Viking CCS Pipeline

9.41 Design Changes 5 to 8: Environmental Technical Note

Document Reference: EN070008/EXAM/9.41

Applicant: Chrysaor Production (U.K.) Limited,
a Harbour Energy Company
PINS Reference: EN070008
Planning Act 2008 (as amended)
The Infrastructure Planning (Applications: Prescribed Forms
and Procedure) Regulations 2009 - Regulation 5(2)(q)
Date: June 2024

FIGURE TITLE
Figure 1
Design Change 5 - Reduction of Order Limits as a Result of Removal of Theddlethorpe Facility Option 2

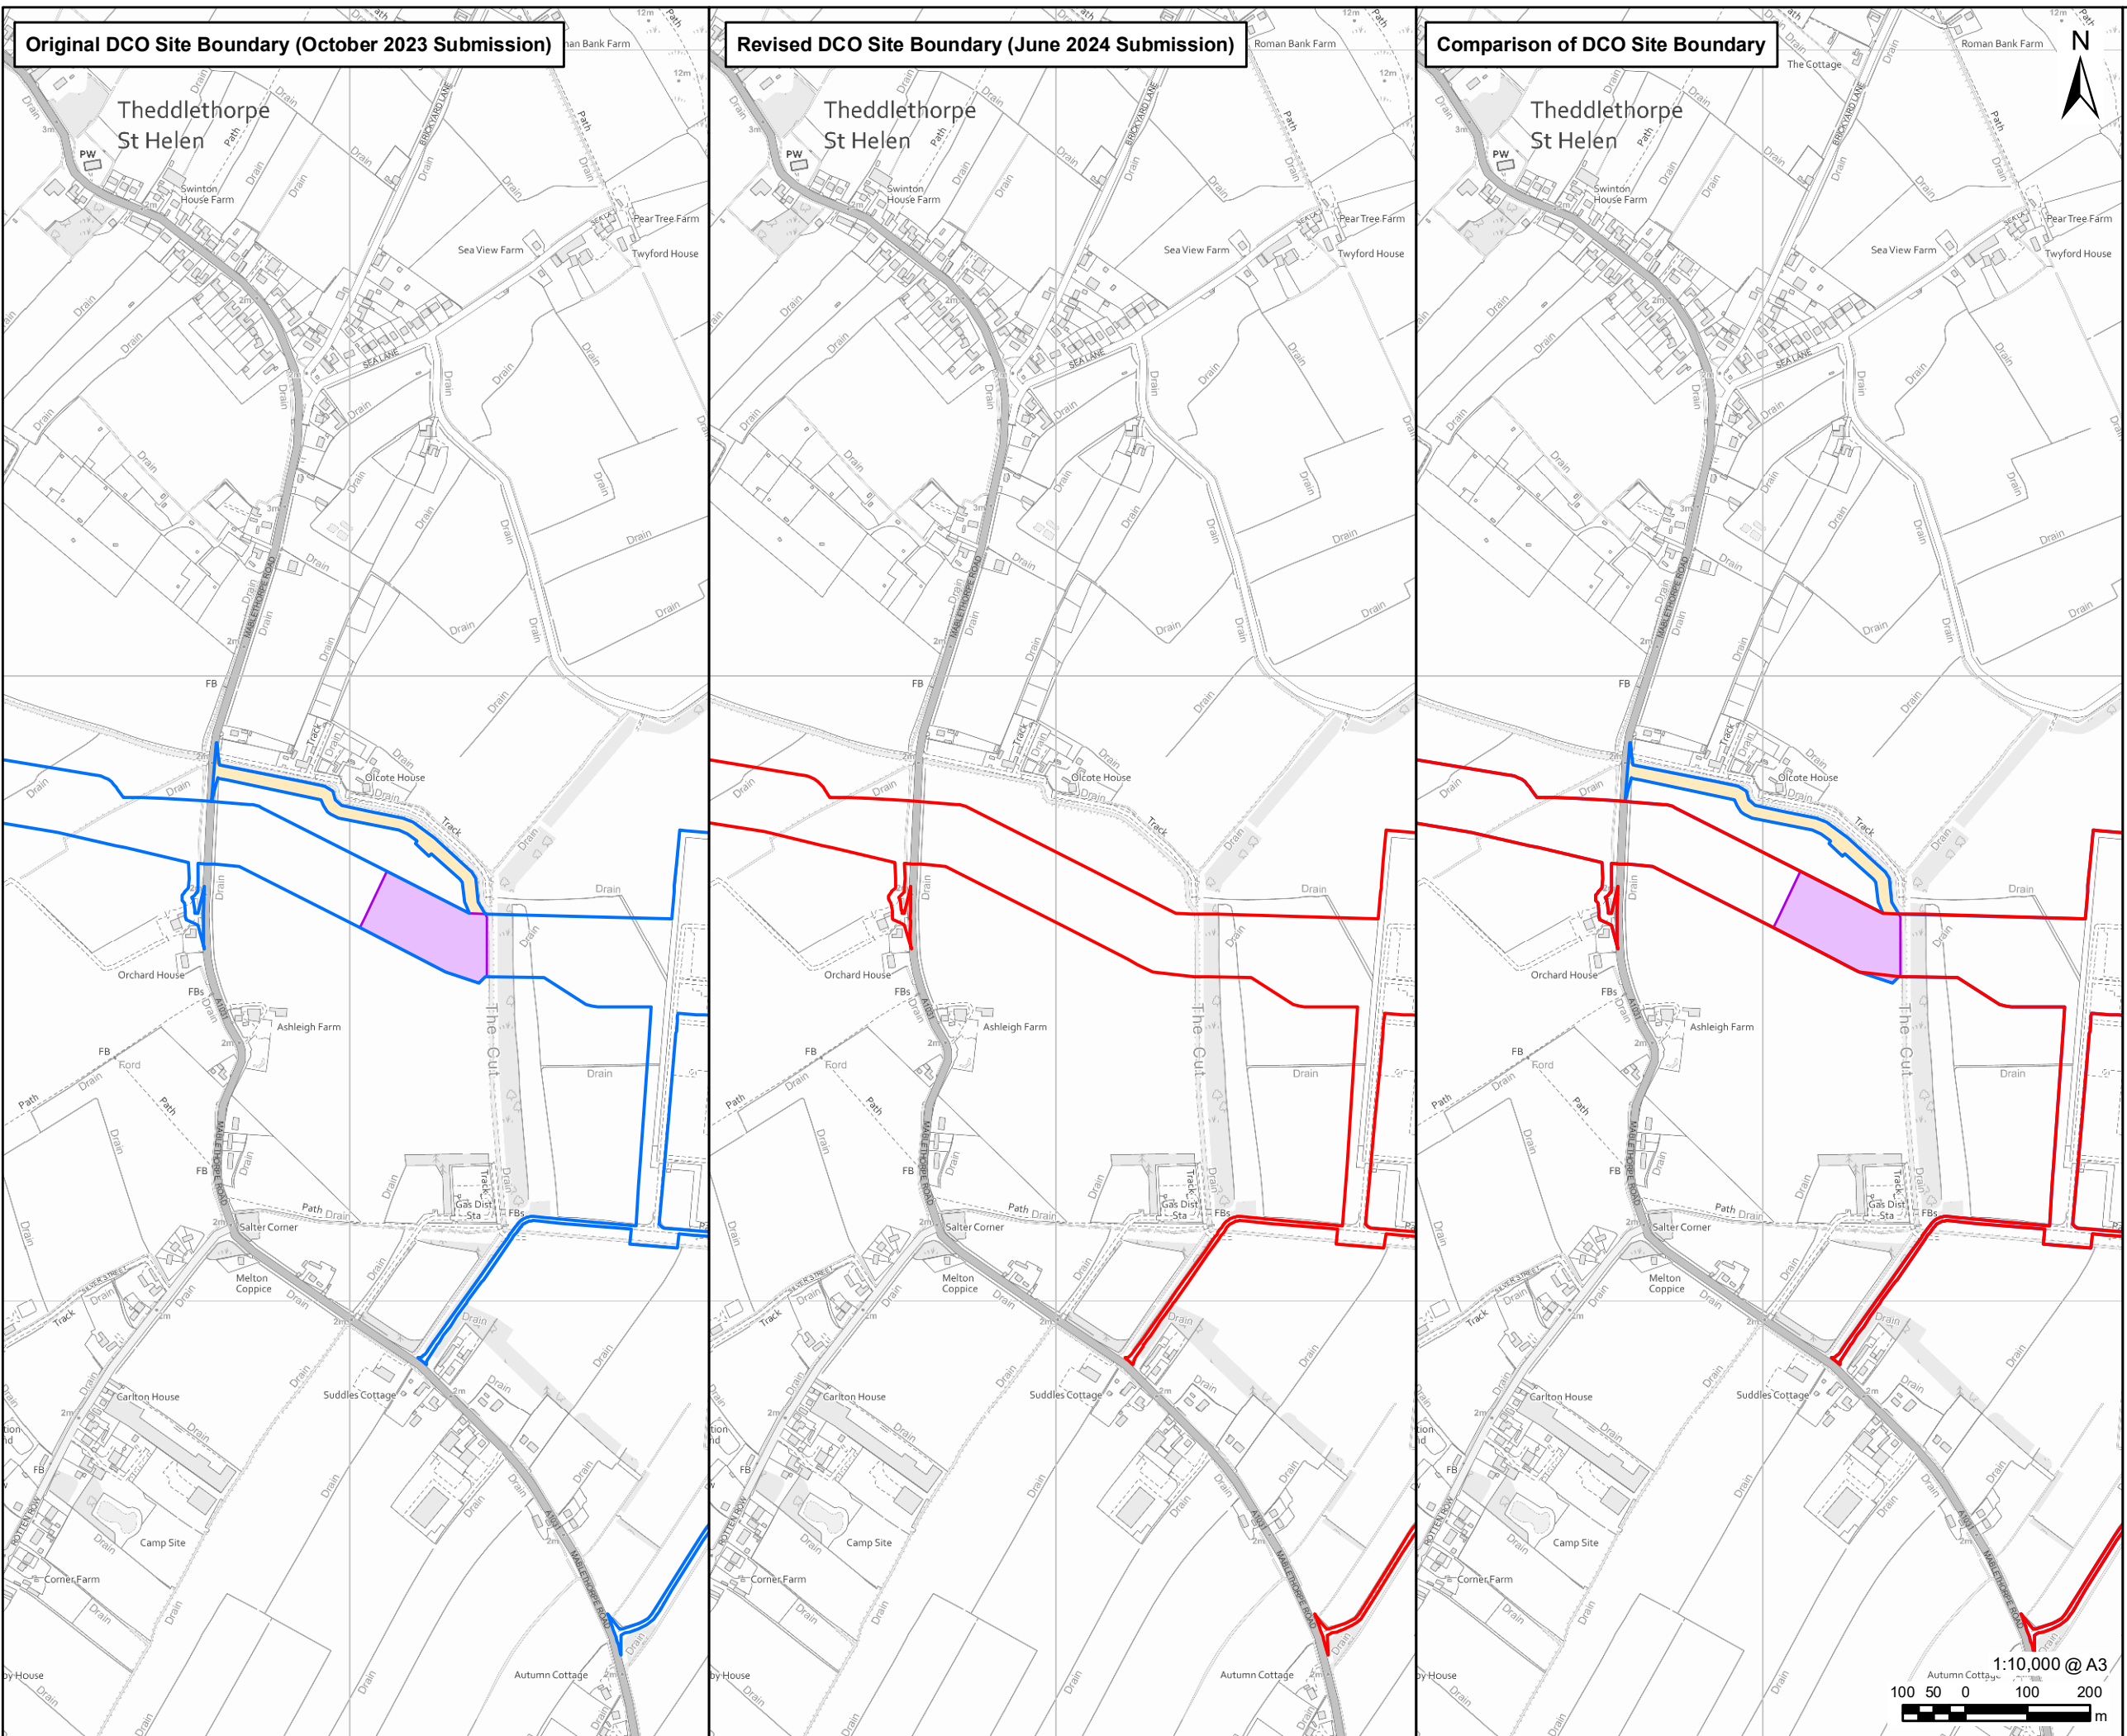
2.2 Design Change 5: Removal of Theddlethorpe Facility Option 2

- 2.2.1 At the point of submission, the Applicant included a degree of flexibility and optionality relating to the location of the Theddlethorpe Facility. The Theddlethorpe Facility will comprise the infrastructure necessary to enable CO₂ to flow from the new 24" pipeline into the existing LOGGS (36") pipeline, then onwards to be stored in the depleted gas fields within the southern North Sea.

- 2.2.5 The Applicant and NGT have now reached agreement on the terms of a voluntary agreement, with engrossed versions of those agreements now going through the final corporate approval processes of the respective organisations. As a result of this progress, the Applicant is now confident that Option 2 is no longer required, and the Applicant is submitting a change request for this option to be removed from the Proposed Development, including the proposed access track off the A1031 Mablethorpe Road.

- 2.2.7 Removing option 2 would not result in any new significant adverse effects as reported in the ES. The change would remove three moderate (significant) effects on the setting of listed buildings (two during construction and one during operation) which would no longer occur. Therefore, the ES conclusions have changed, but only in terms of a reduction in potential for significant effects.

FIGURE TITLE
Figure 2
Design Change 6 - Amendment of Order Limits around the former TGT Site

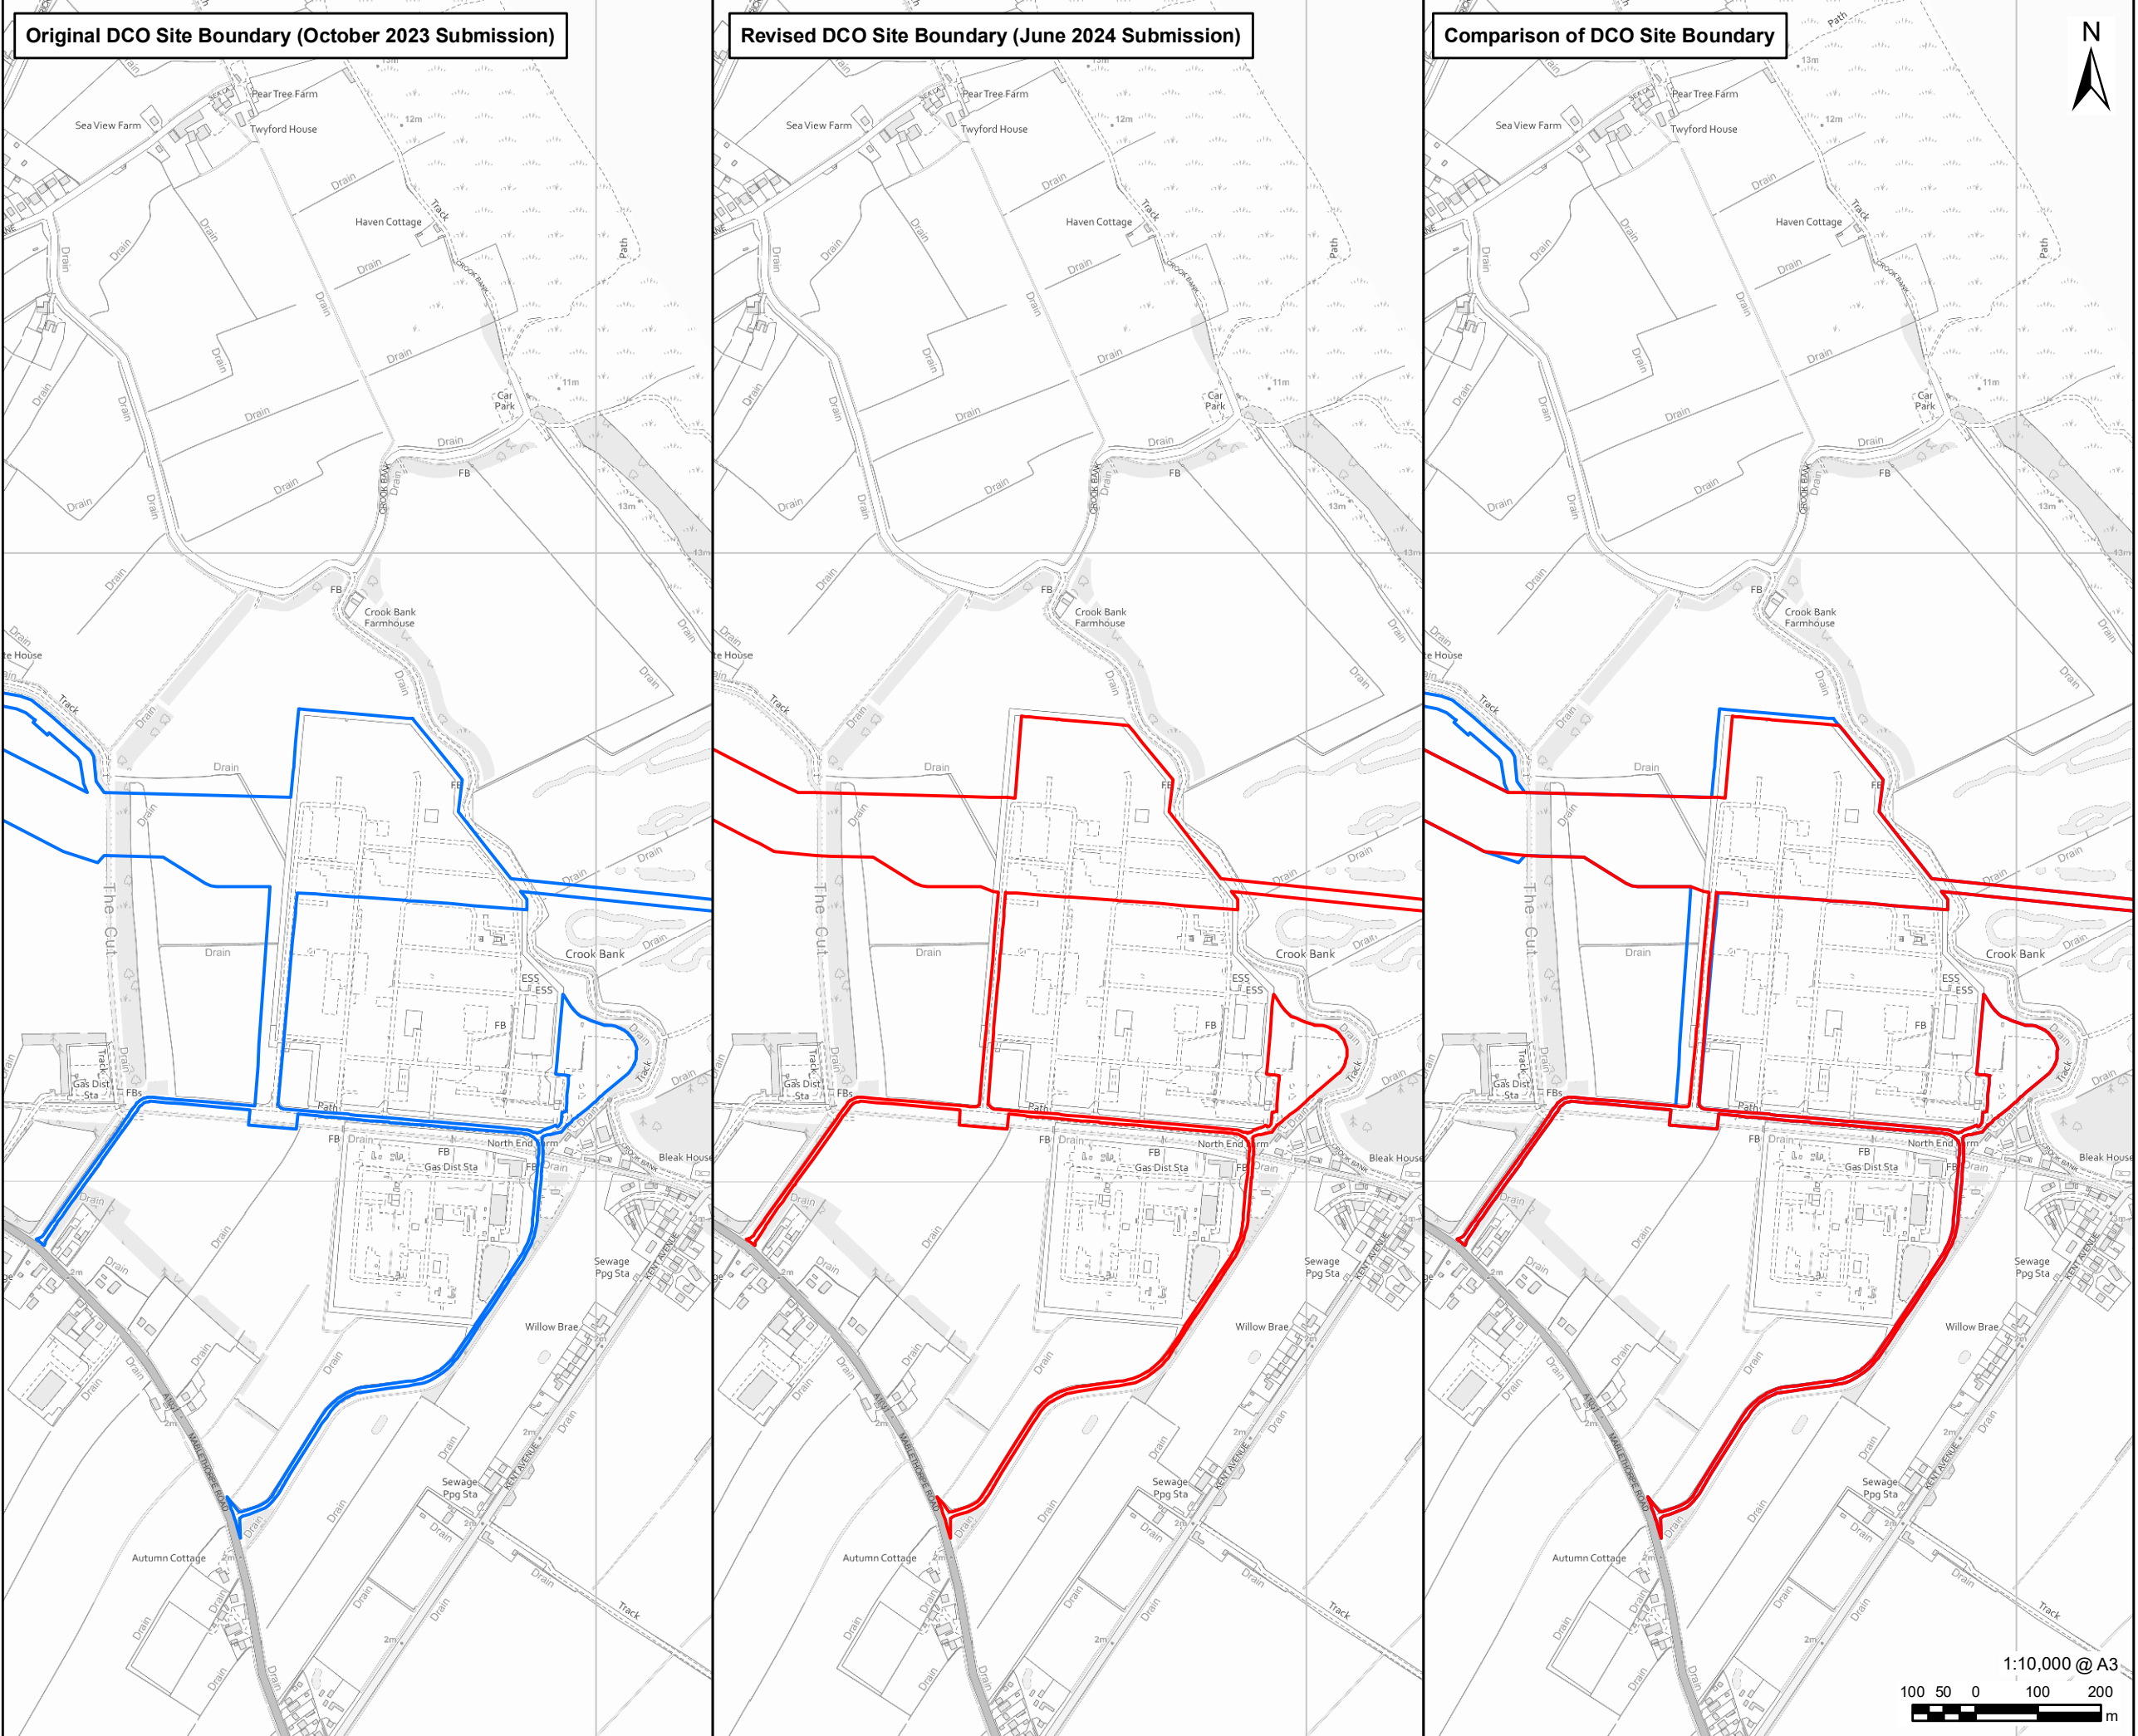
2.3 Design Change 6: Reduction of Order Limits around the former TGT

- 2.3.1 Following on from the Applicant's ongoing discussions with NGT and Mablethorpe Flexible Generation Limited, as part of the voluntary agreement that would allow use part of the former TGT site for the Theddlethorpe Facility, a number of minor amendments are required to the Order Limits. These changes would result in alterations to the Order Limits associated with the Works Nos listed in paragraph 2.1.4.

- 2.3.2 The changes would also result in the removal of plots 35/8, 35/9, 35/10, 35/11 and 35/13 from the Land Plans. The nature of rights sought over plots 35/14 and 35/15 would also be amended from seeking permanent acquisition to seeking permanent acquisition of the subsurface only. The change would reduce the area of land included in the Order Limits and would not engage any new land interests. No additional land outside of the current Order Limits would be required.

- 2.3.3 As the Order Limits would be reduced, and none of the land was previously required for mitigation measures, this change would not result in new or different likely significant environmental effects to those reported within the ES.
